STERLING RANCH ROAD & BRIARGATE PARKWAY STORM PLANS

STORM SEWER PLANS

PCF FILING NO.: CDR 221

v4_CDs Storm.pdf Markup Summary

DP18 PROFILE(1)
STA 10+00.00 TO 15+00.00
PUBLIC

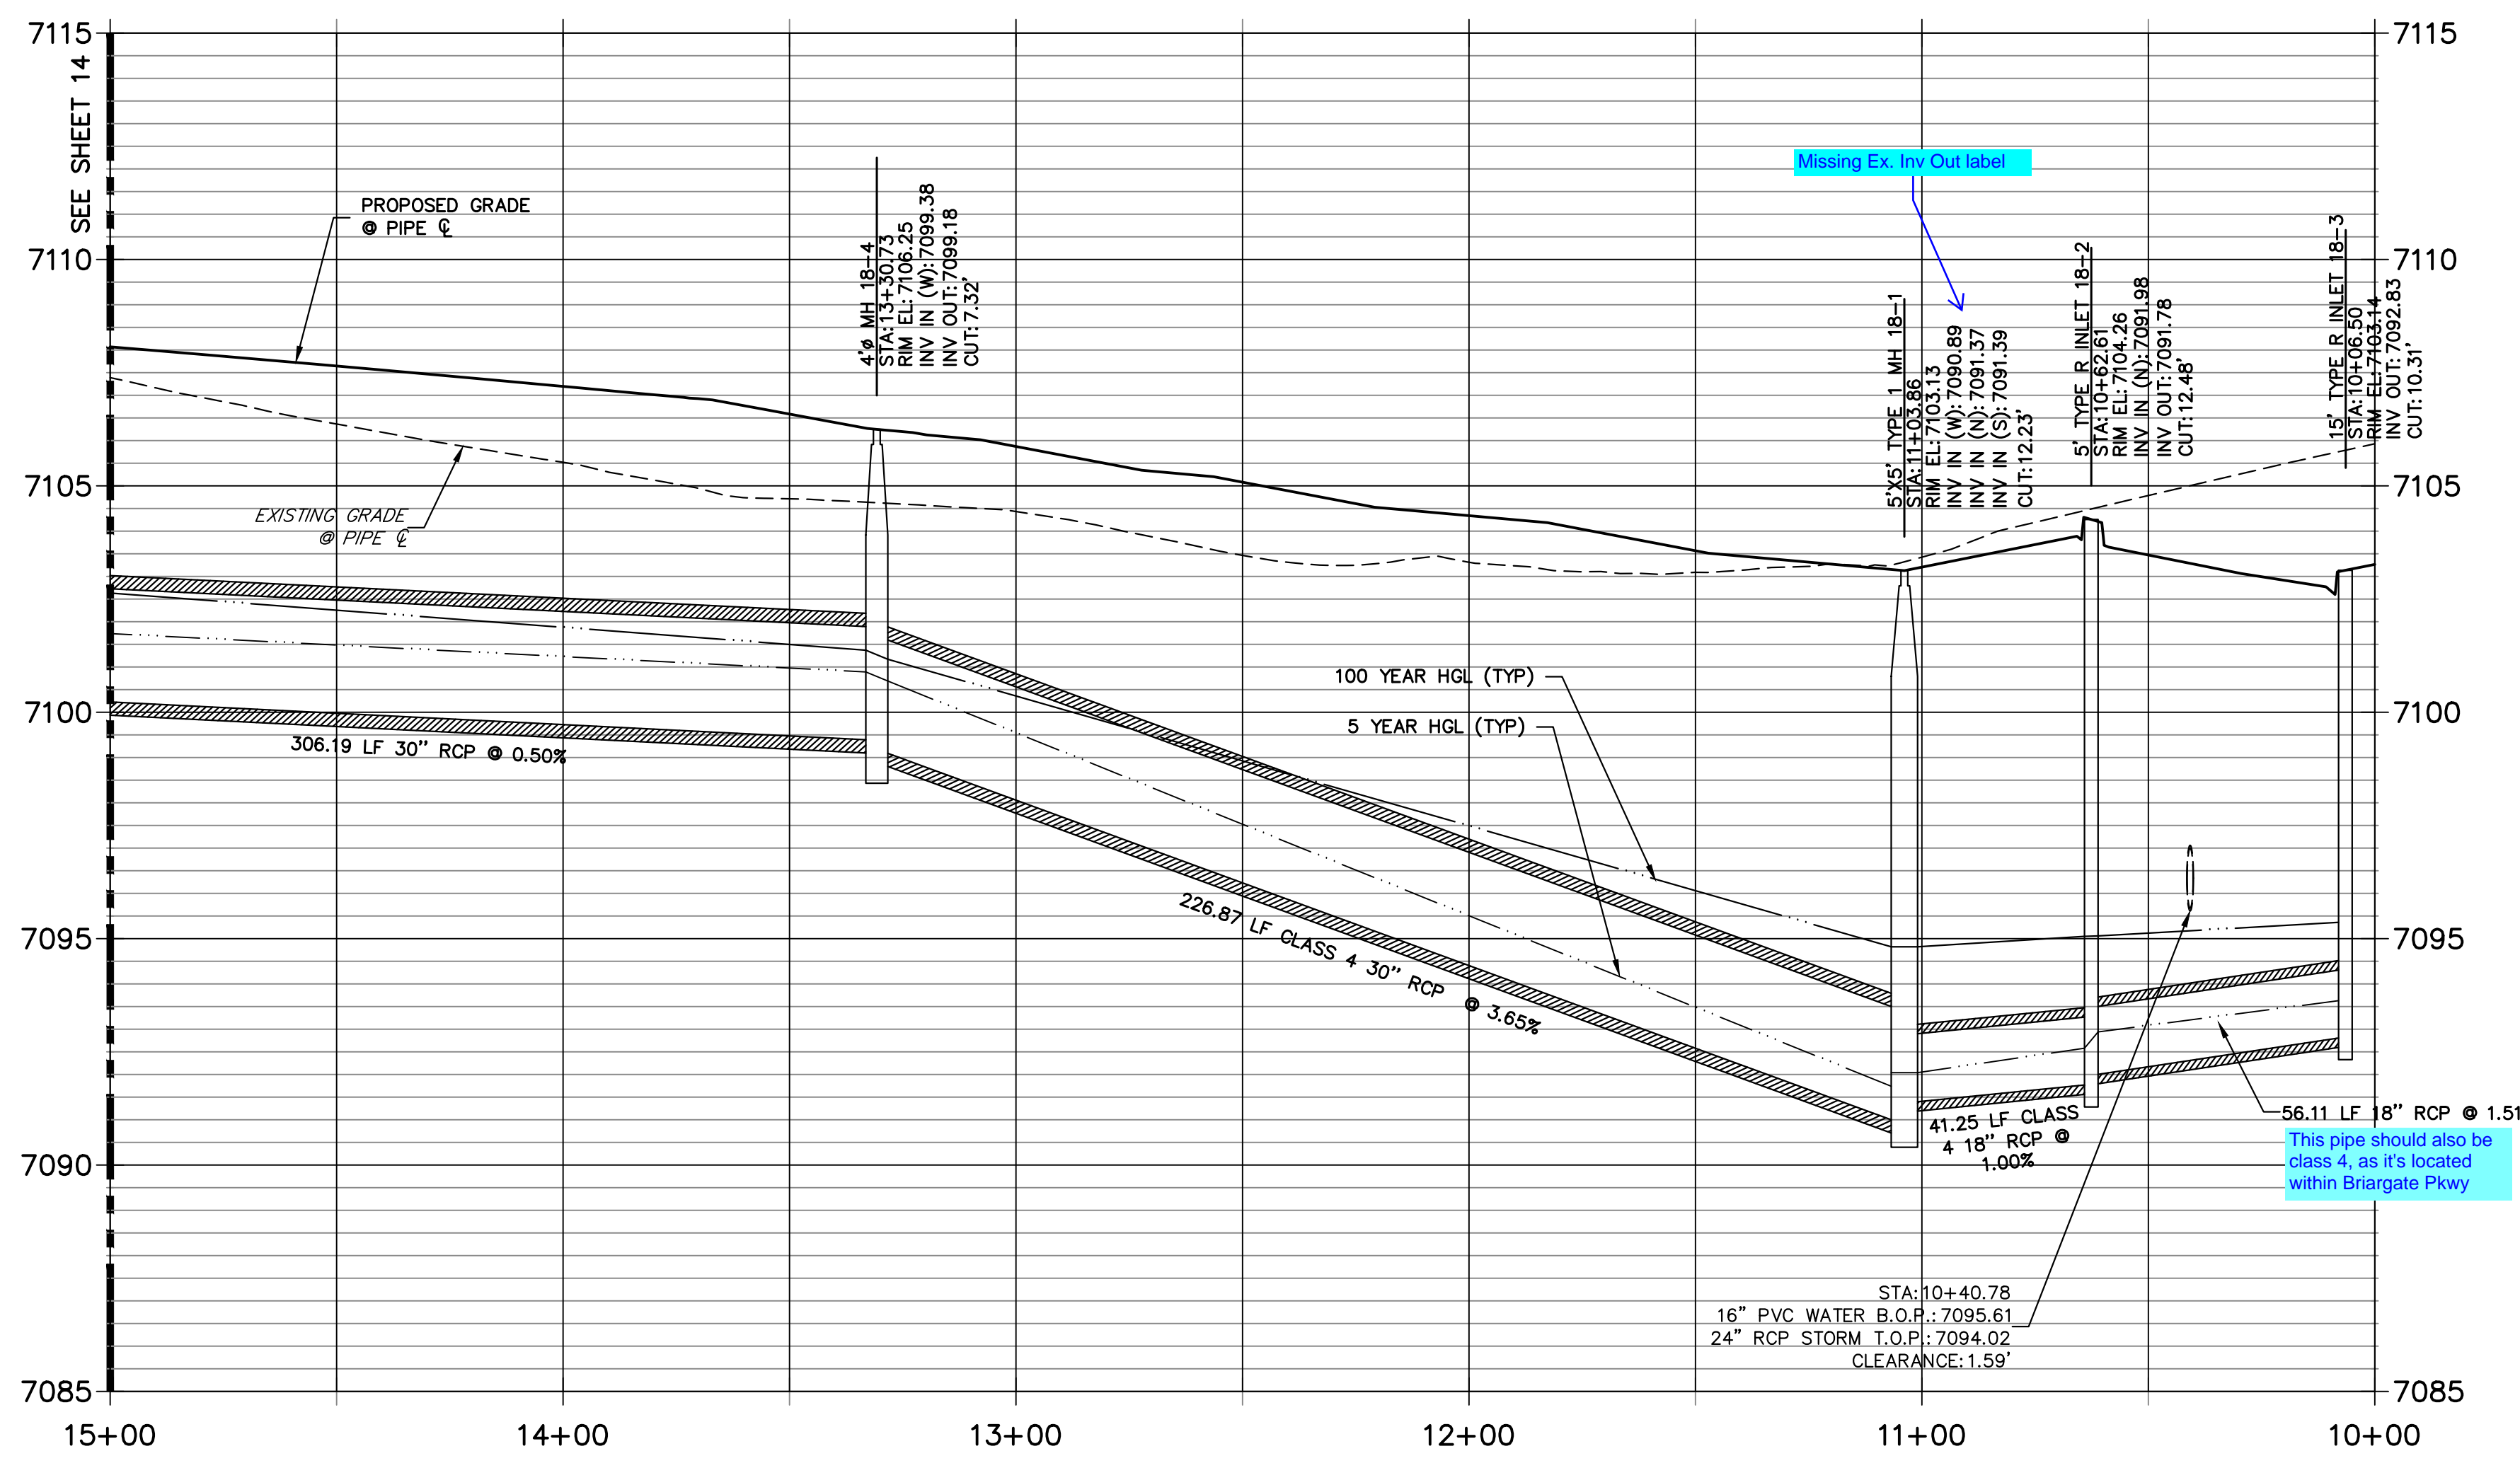
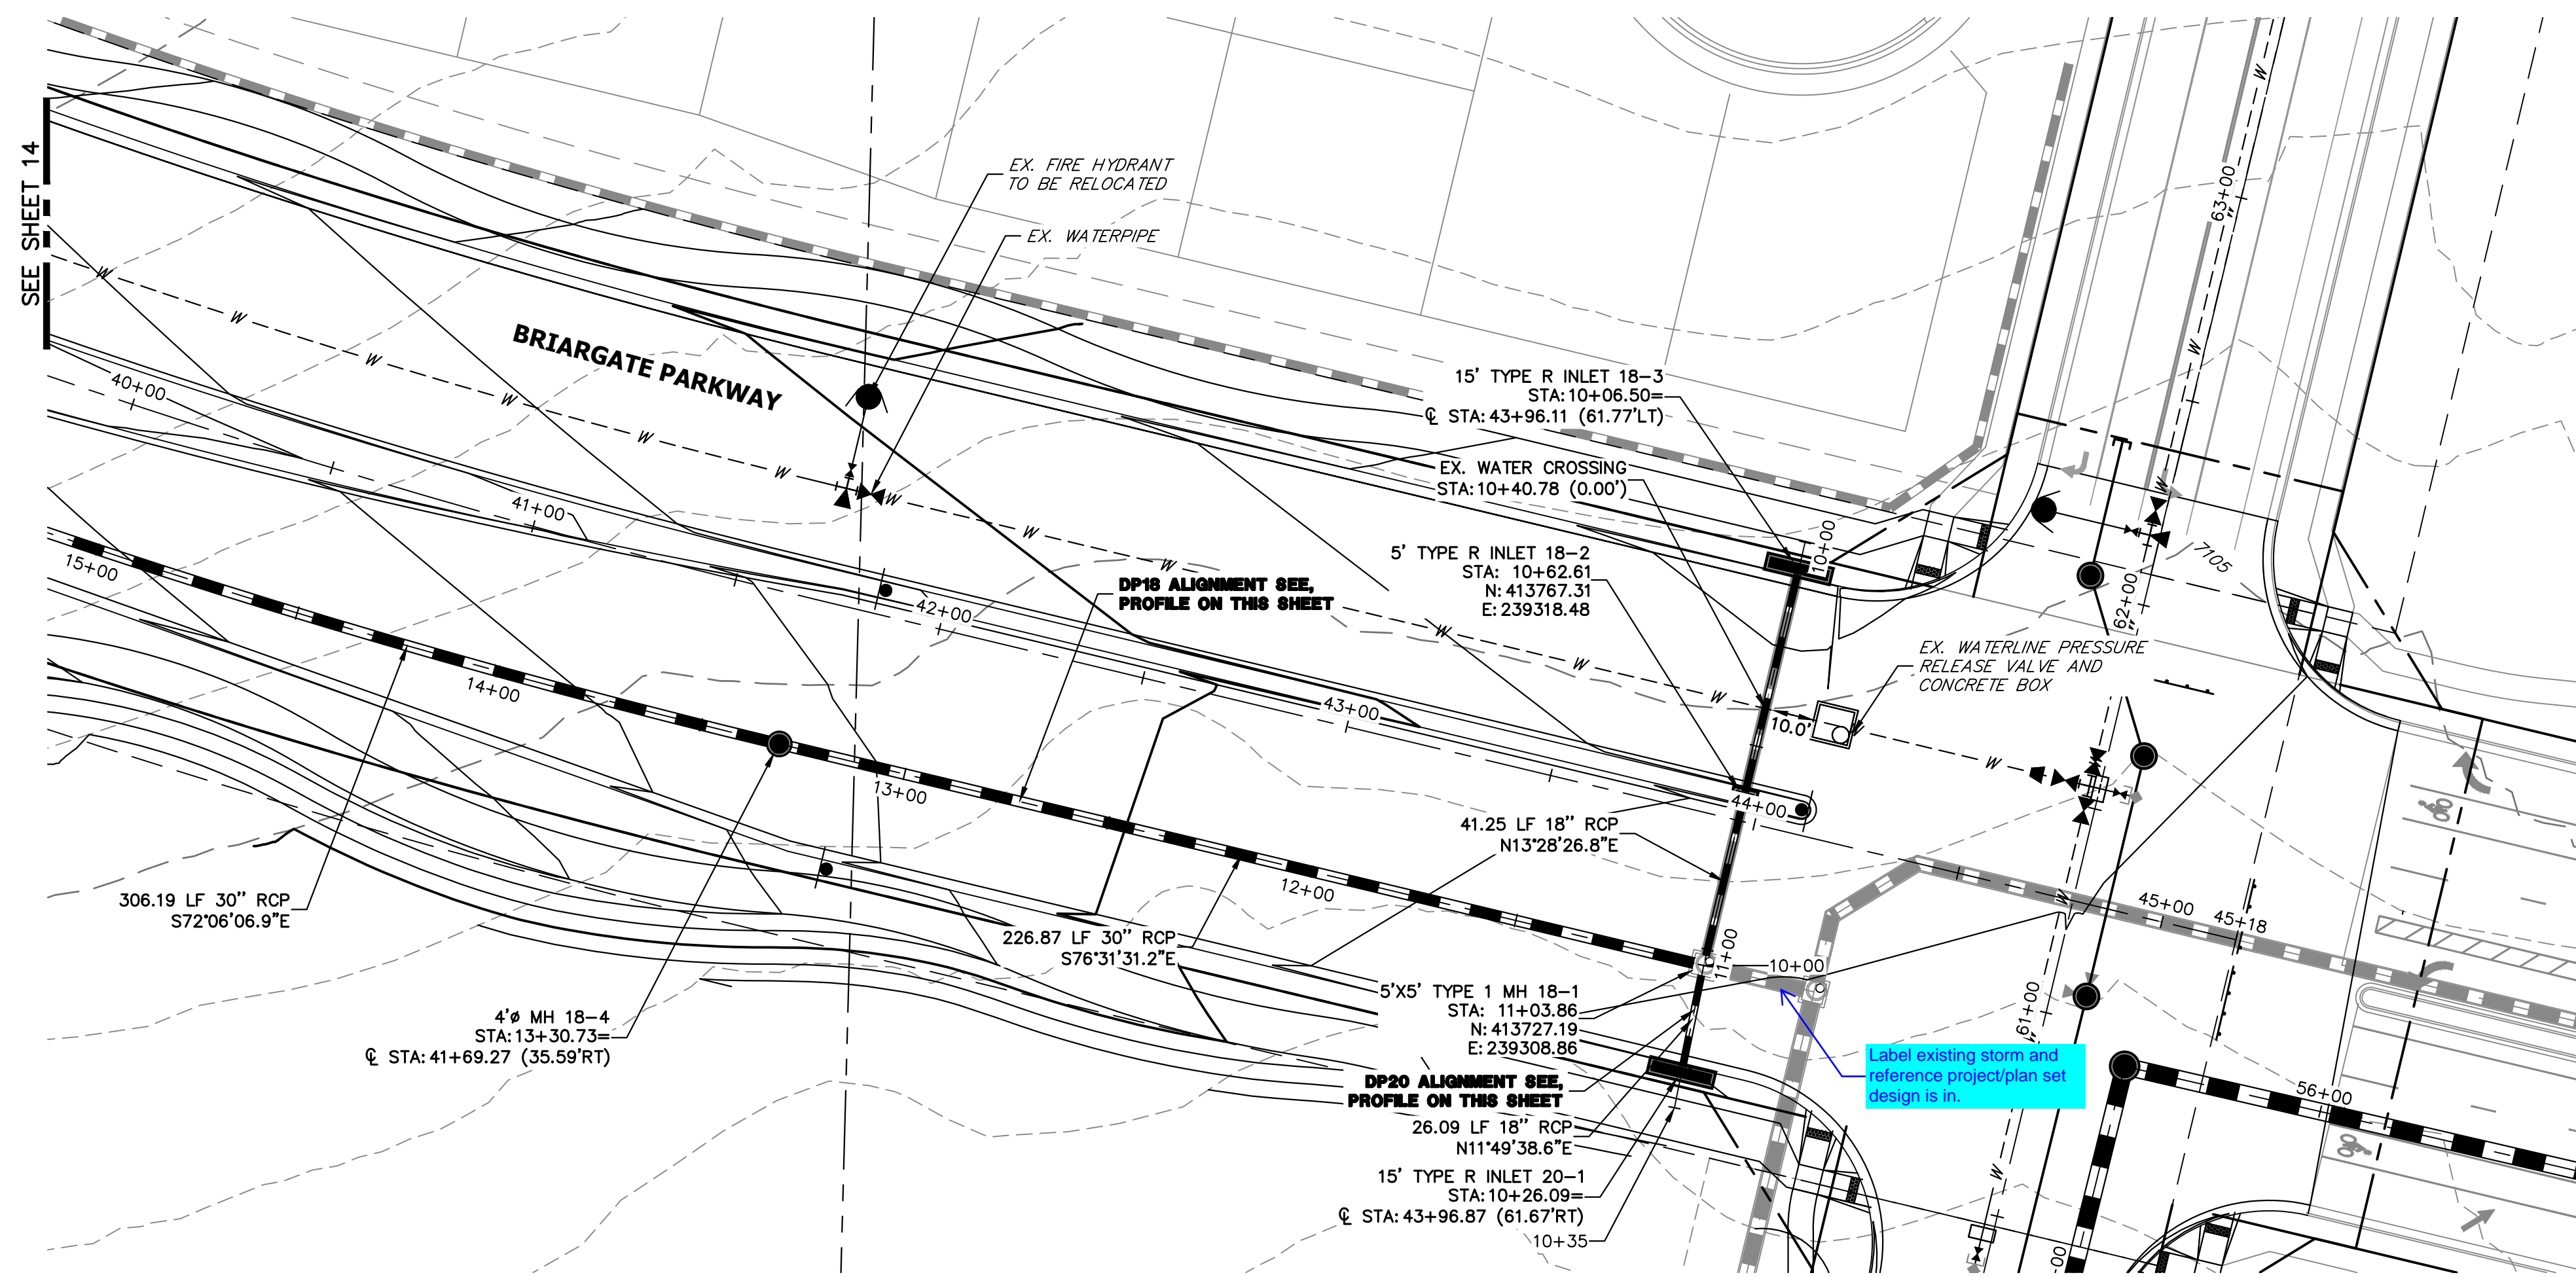
Class 4 pipes
